Permit No: 9907067
Insp Area: 2

Site Address: 7024 AMHERST ST SAC
Parcel No: 035-0343-003

Nature of Work: PATIO ROOM ENCLOSURE-- 275 SQ FT

City of Sacramento Development Services Division Planning and Zoning Information Request

PLOT PLAN

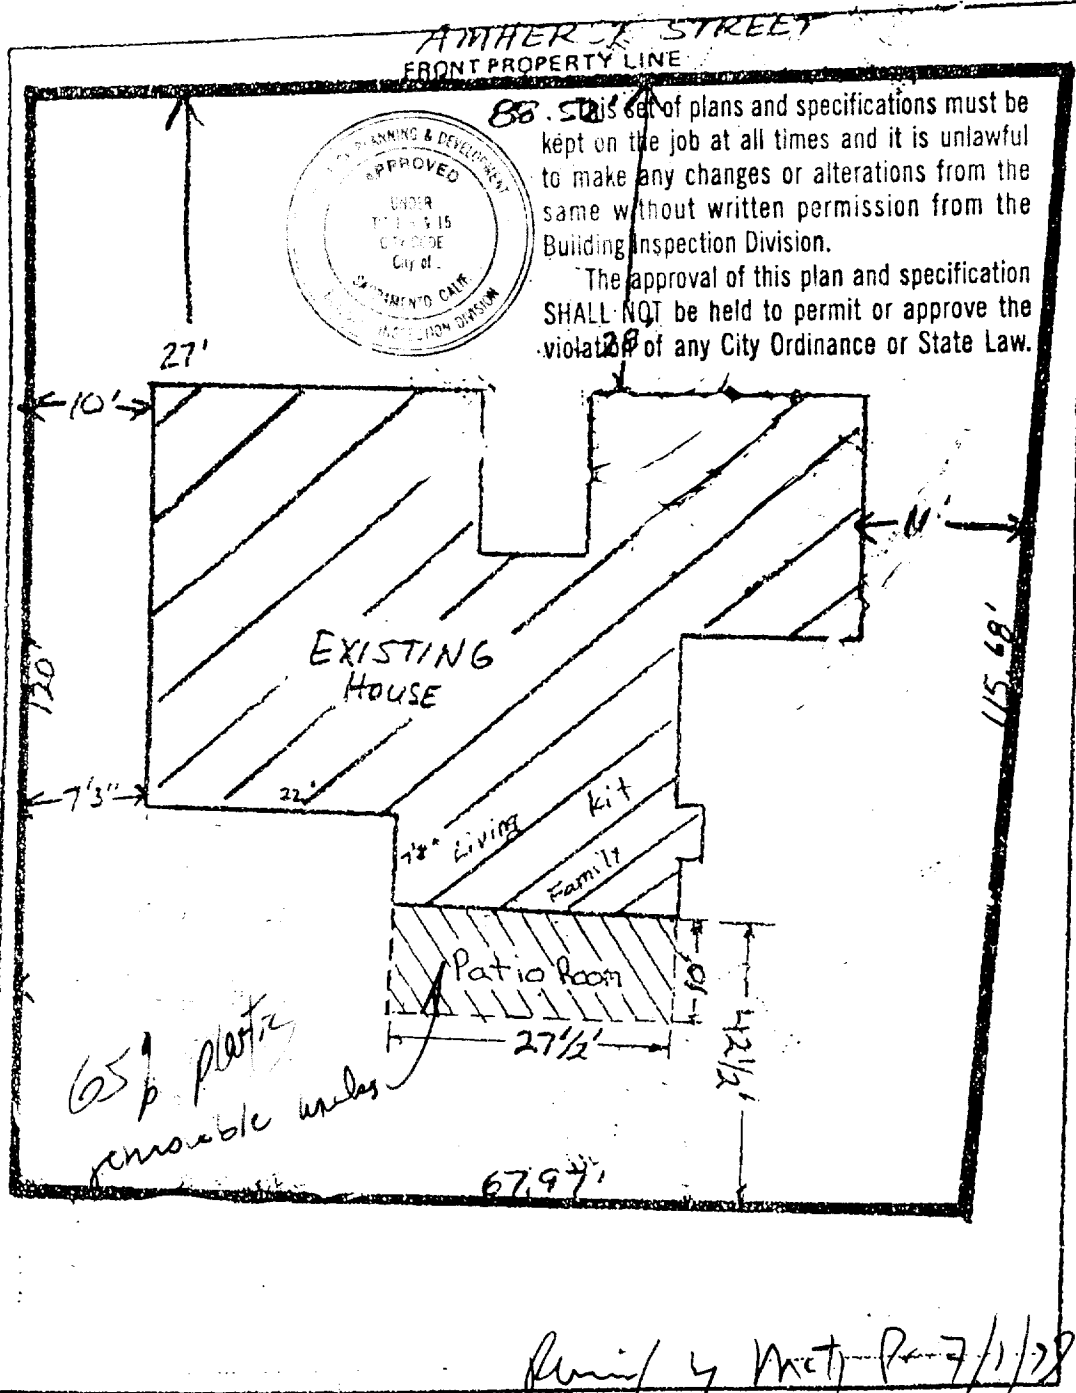
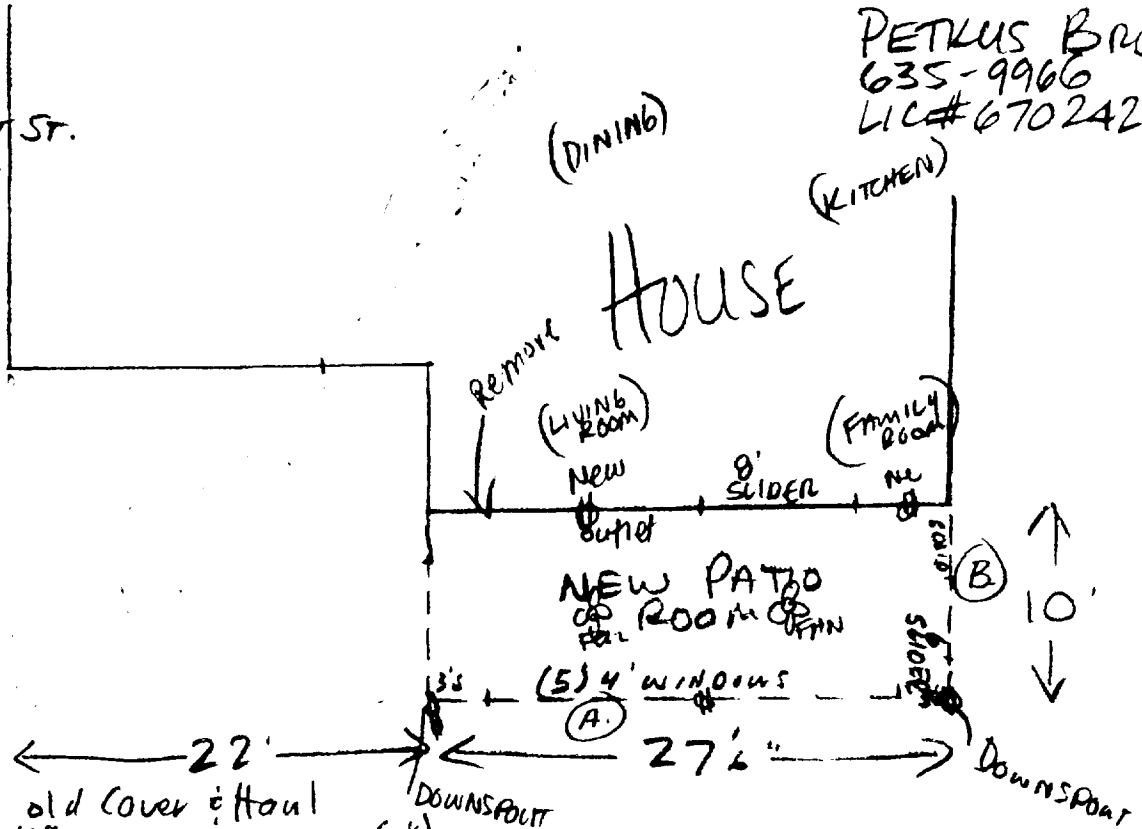
Comments: Checked lot coverage

Setbacks

NOT DR Area

1400
275
1675
